MIL-H-83190 (USAF)
AMENDMENT 3
8 November 1972
SUPERSEDING
AMENDMENT 2
14 February 1972

MILITARY SPECIFICATION

HOLDER ASSEMBLY, CHART-LET-DOWN, PLU-4/A AND PLU-5/A

This amendment forms a part of Military Specification MIL-H-83190 (USAF) dated 18 December 1969.

FIGURE 1. Chart-Let-Down Holder Mounting Provisions

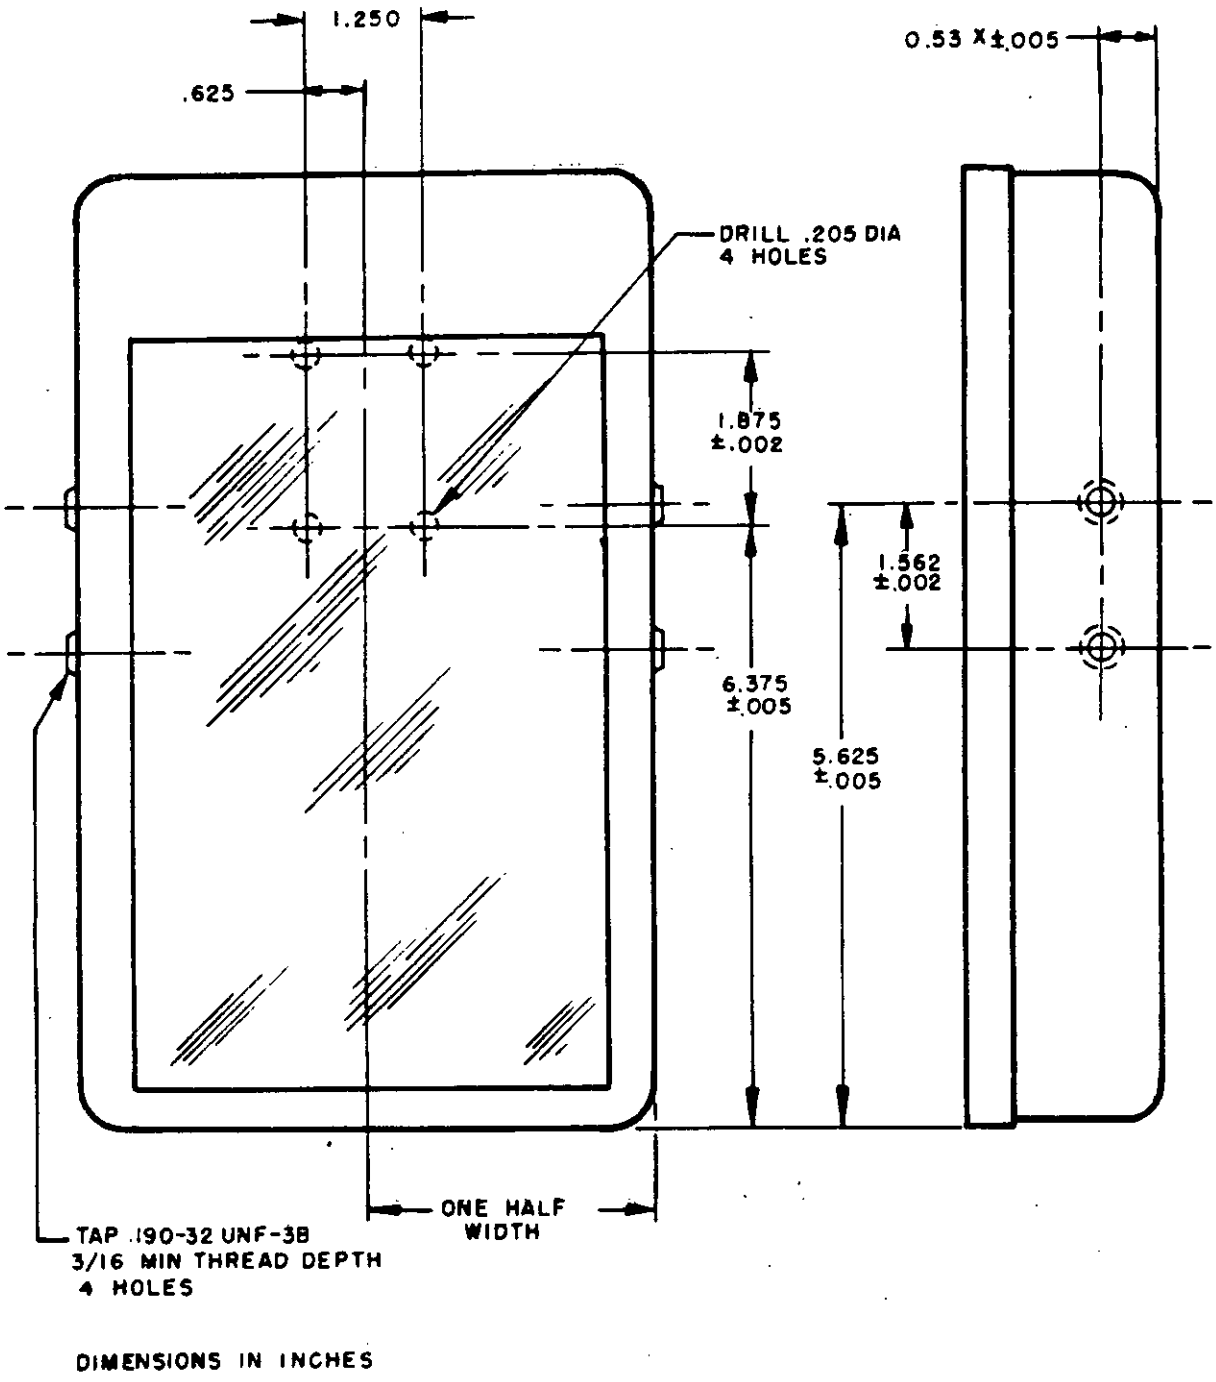
Page 5, figure 1: Delete and substitute the attached figure 1. Figure 1 forms page 3 of this amendment.
